Planning Commission Staff Report

Project Type: Site Development Section Plan

Meeting Date: April 25, 2016

Description: **Peter Steffan, Proposed Lot 1 (AutoZone):** A Site Development Section Plan, Landscape Plan, Lighting Plan, Architectural Elevations, and Architect’s Statement of Design for a 0.88 acre tract of land zoned “PC” Planned Commercial District, located north of Chesterfield Airport Road west of its intersection with Arnage Boulevard.

Figure 3—Architectural Elevation as presented at ARB

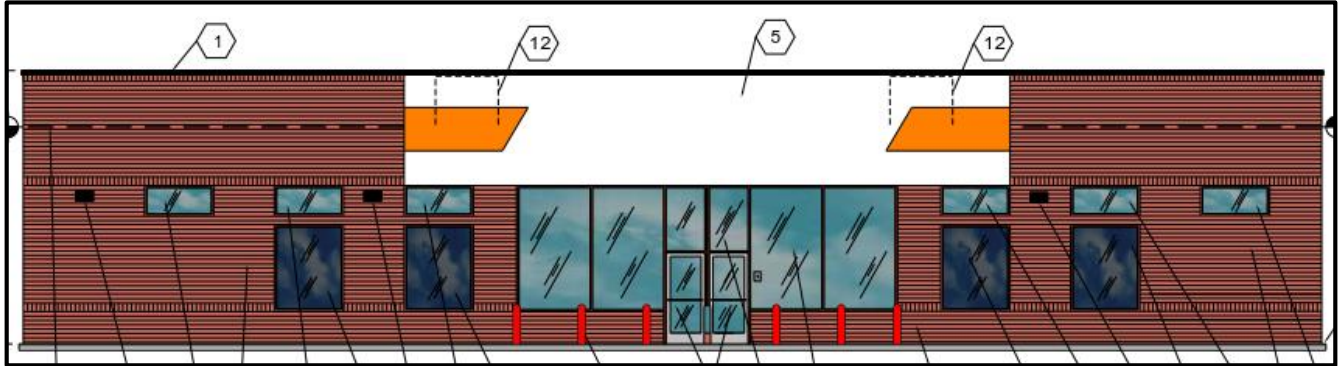
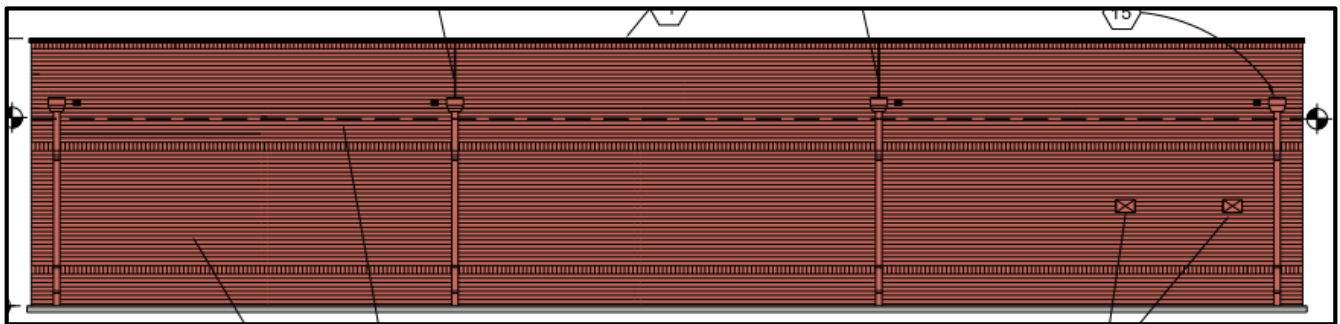
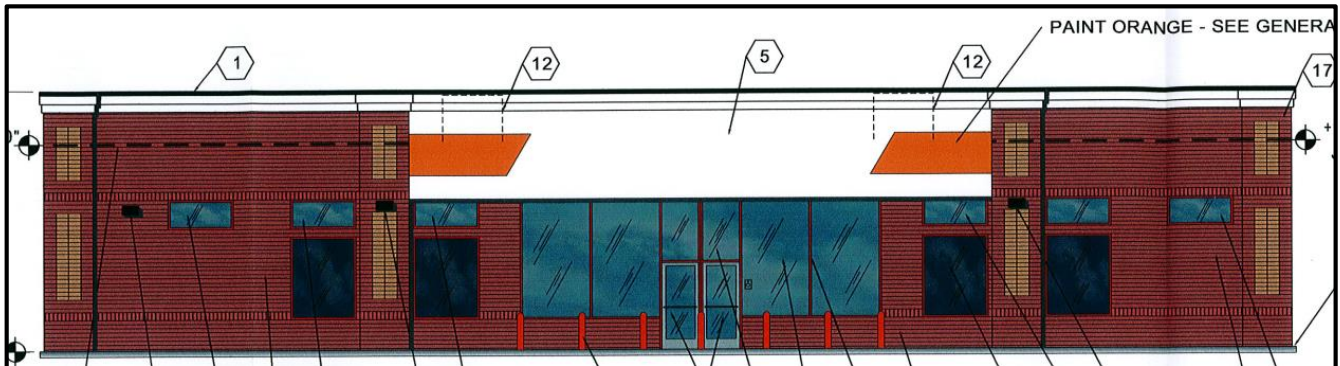
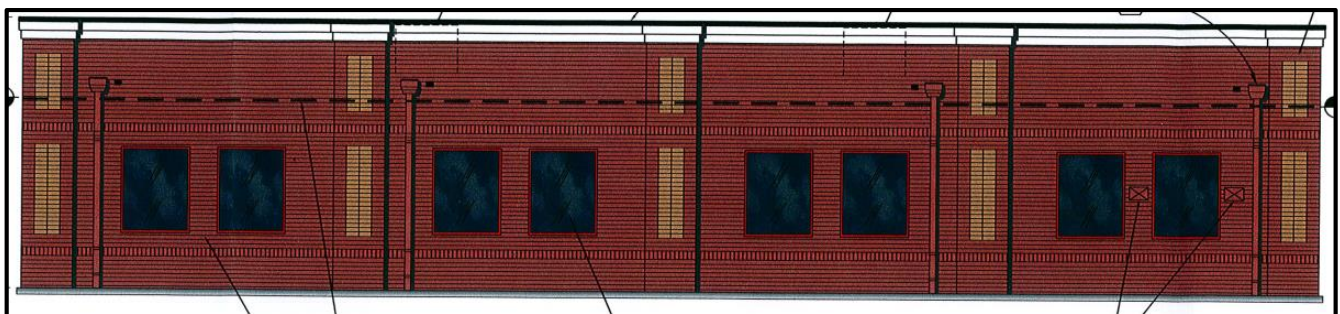
1. The building design should include architectural elements to add depth and to break up the flat façade through change of color, material, or building articulation.
2. Treat the design as a “four sided” building and take into consideration future development of the properties behind the proposed development.
3. The architectural renderings should accurately correspond to the material and color samples provided.
4. Reconsider the location and design, including material and height, of the retaining wall and consider incorporating landscaping to delineate the wall from the adjacent drive aisle.

In response to the ARB’s recommendations, the Applicant has revised the architectural elevations to add greater architectural detail and material and color variation across all four façades. A white cornice tops the parapet walls around the building, and pilasters add depth and articulation. Stacked courses of a tan brick within the pilasters provide color and texture variation. The architectural elevations and renderings have been revised for consistency. Additionally, although additional landscaping was not incorporated into the retaining wall design, a 48 inch black metal fence has been added to the top of the retaining wall to delineate the wall from the adjacent parking area and ensure safe vehicular circulation in this area.

Staff finds that these revisions sufficiently address the ARB’s recommendations and bring the building into compliance with the Chesterfield Valley Design Policy presented on page 2 of this report. Specifically, the revisions result in a four-sided building that is “equally uniform in materials and attractiveness” on the elevations visible from Chesterfield Airport Road, as well as the rear elevation which will be more prominently visible with the extension of Arnage Road and future adjacent development.
